1. New door handle; removal of sliding mechanism. Handle acts only as a grip point, not as a closing mechanism (mechanism relocated).

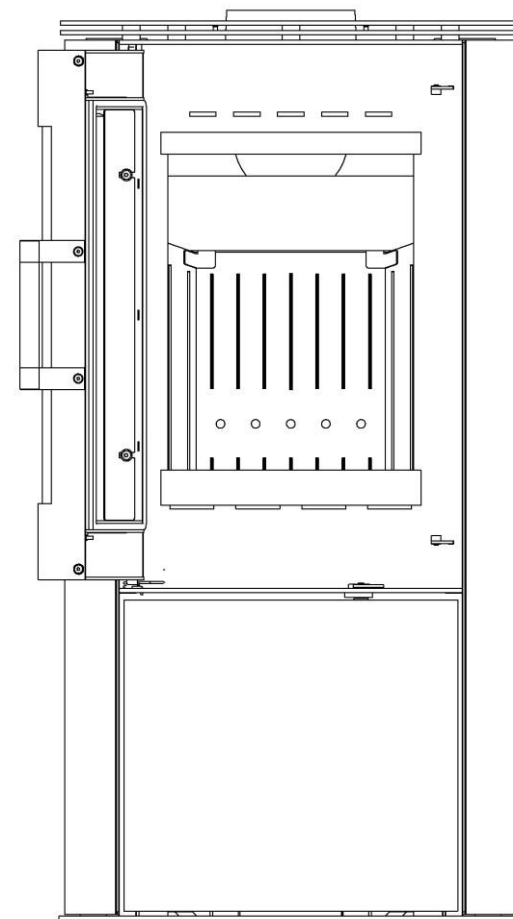
2. Modified combustion chamber;

- the chamber was lowered by changing the height of the lining
- Changed the height of the air curtain and secondary air openings
- Mounting/stabilizing brackets for TERMOTEC lining

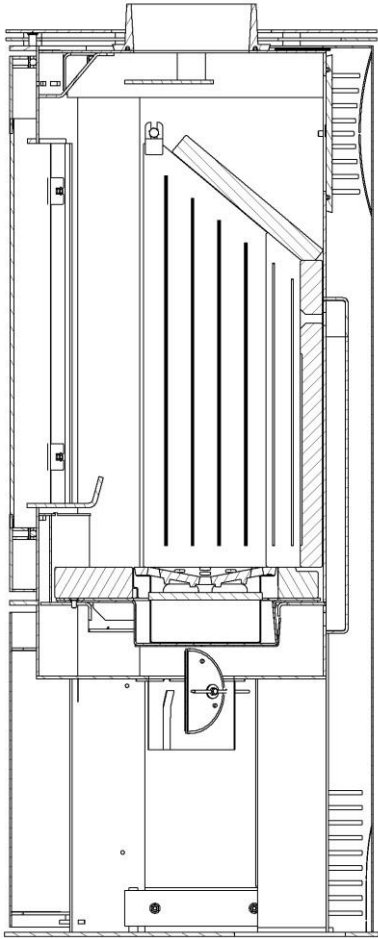
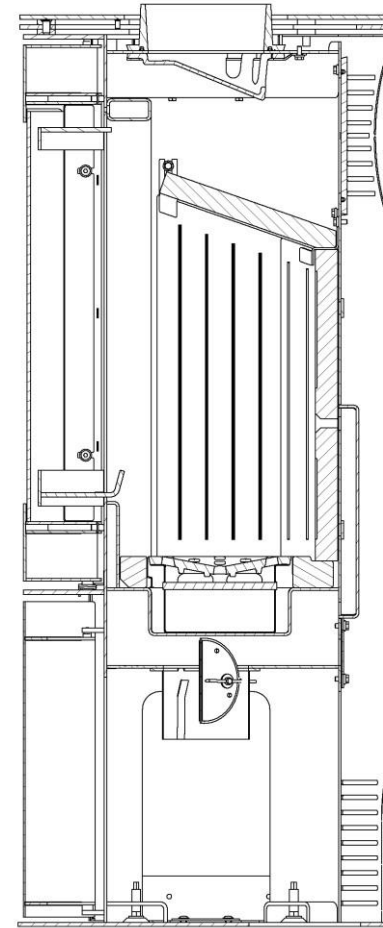
- changing the angle of the deflector and the shutter in the flue connection

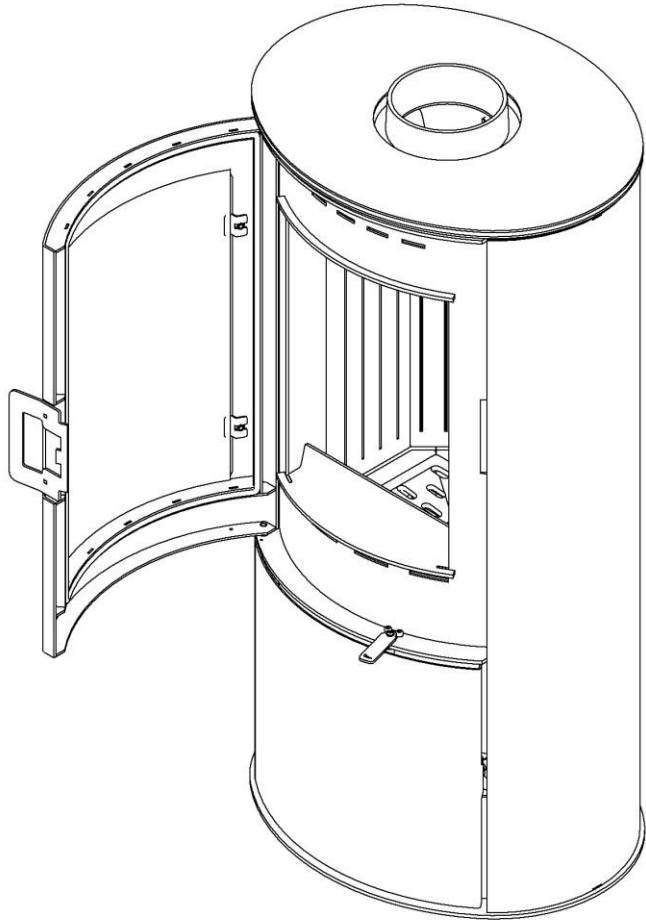
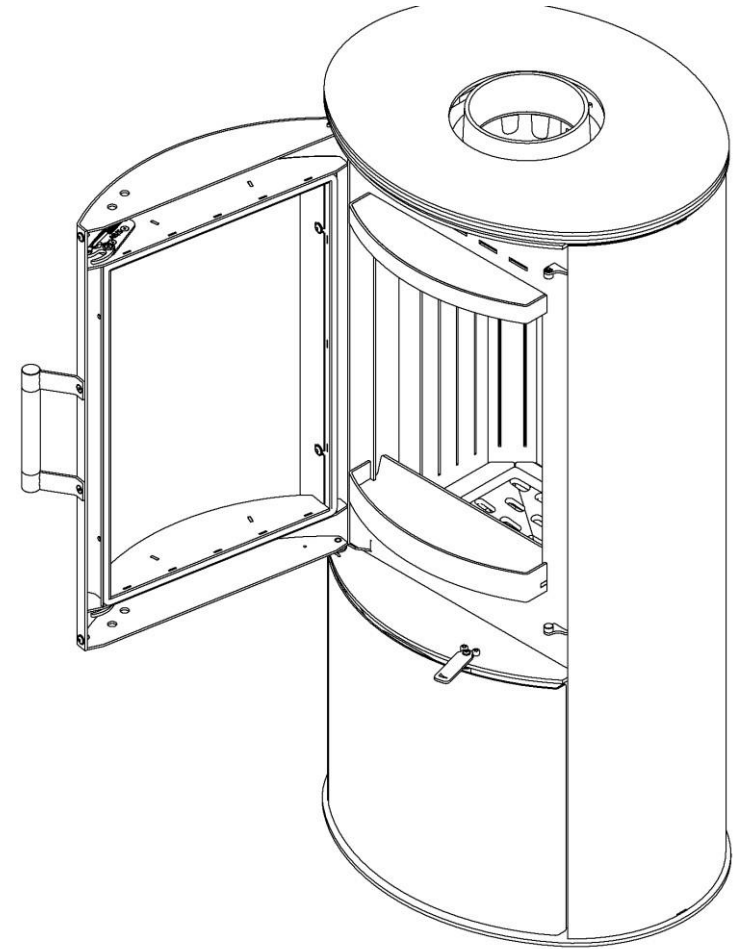
3. Changed profile of the door, fence, air curtain
- applied closing mechanism
 - Changed door profile, hurdle and air curtain

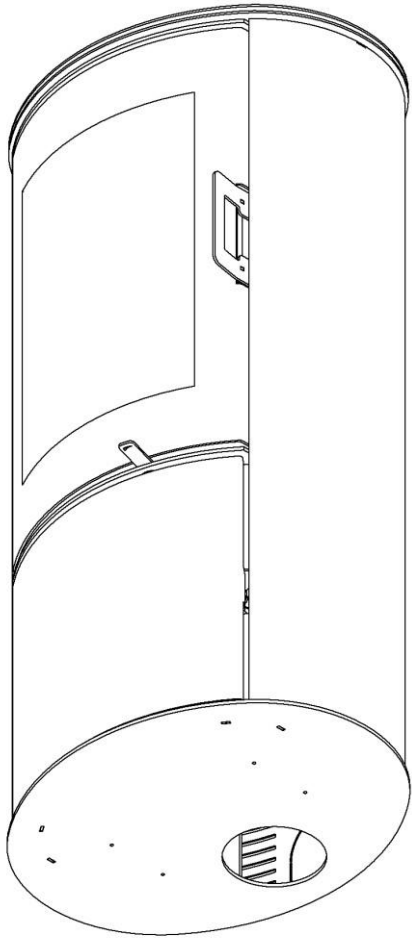
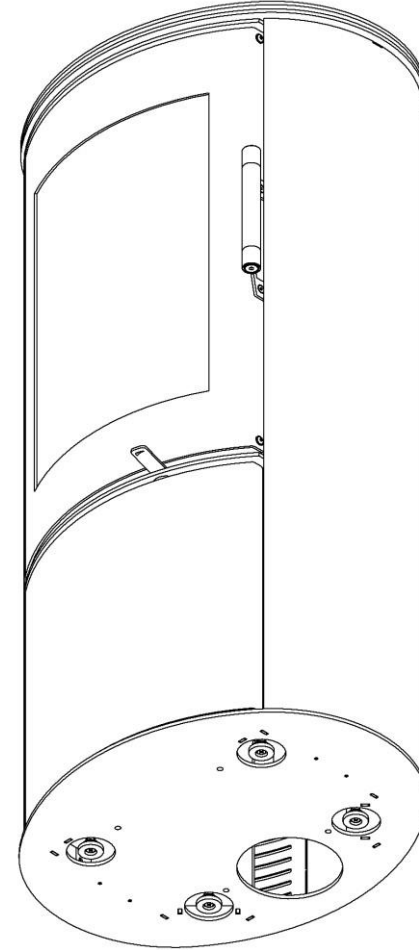
4. Adjustable levelling feet

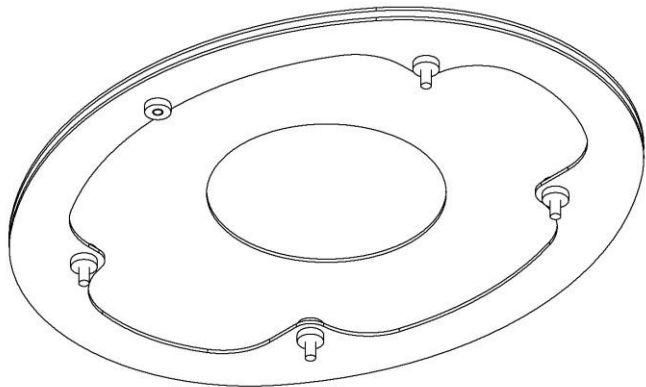
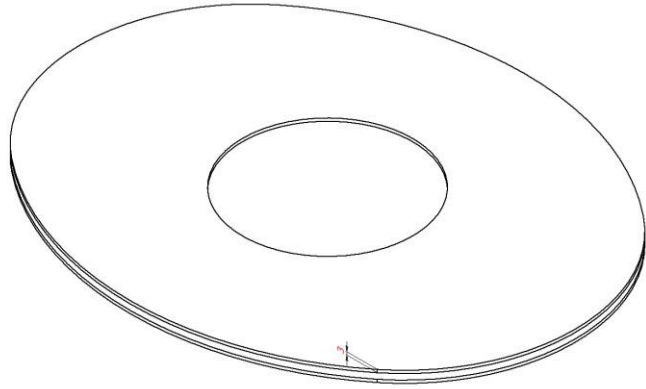
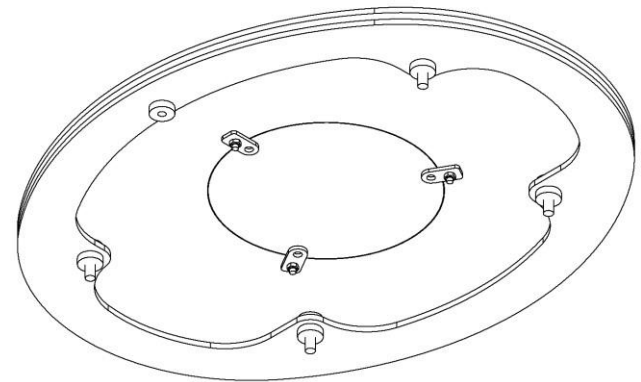
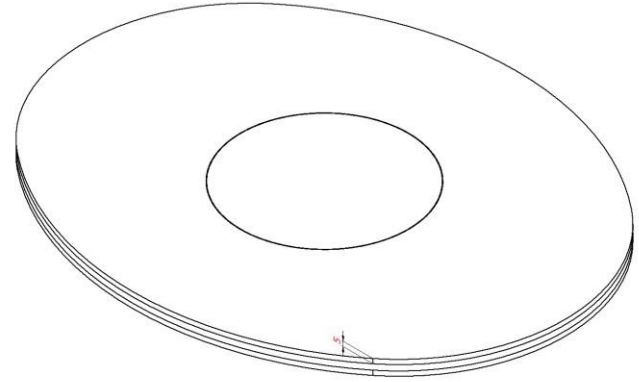
5. Top plate made of 5mm thick sheet metal.

FORMER
3mm

CURRENT
5mm

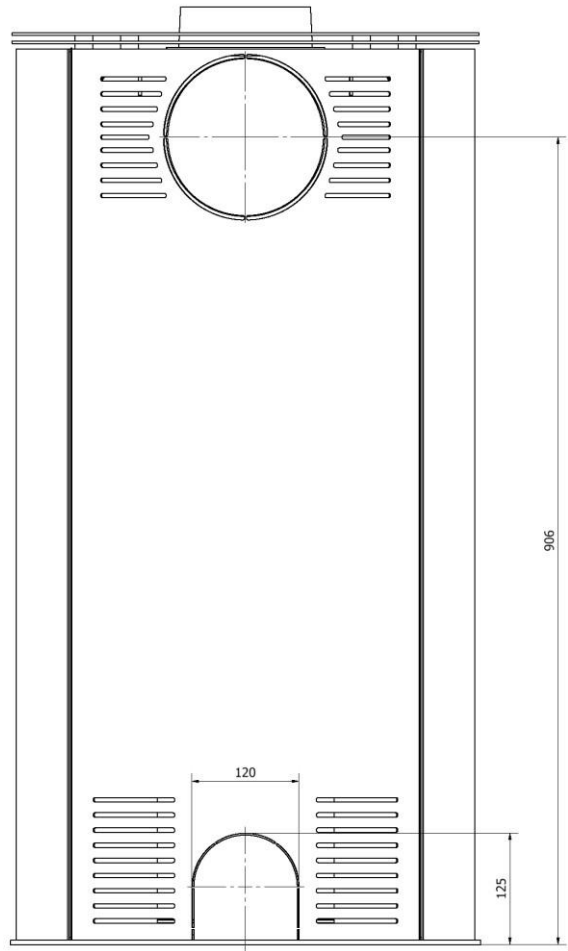
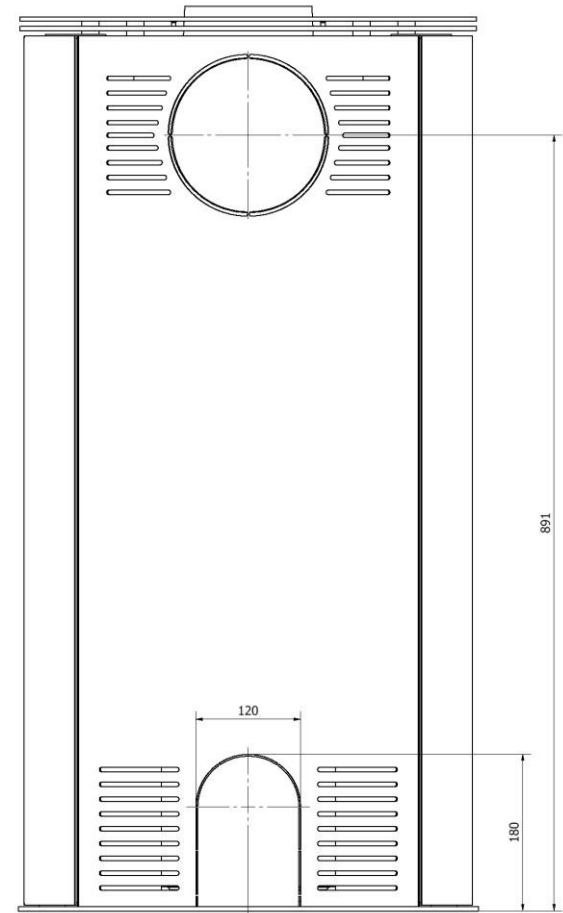
6. Changing the height of the rear flue connection
